Network Video Recorder

Version: V3.4.92 build161228

Release Note

(2017-3-13)

DDNS Type dropdown menu:

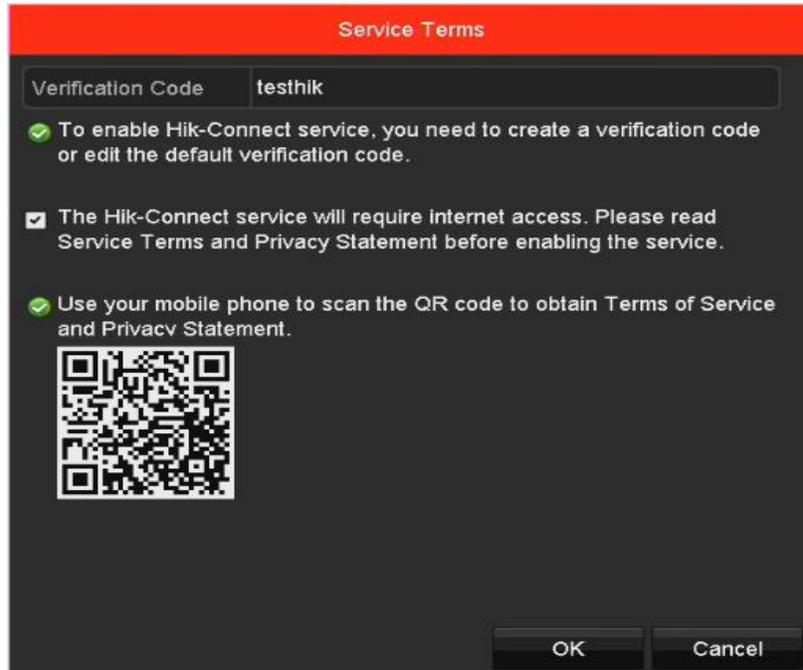
1. [DDNS]

Delete HiDDNS and IPServer access. Available DDNS access include DynDns, PeanutHall, NO-IP.

- DynDNS
- DynDNS**
- PeanutHall
- NO-IP
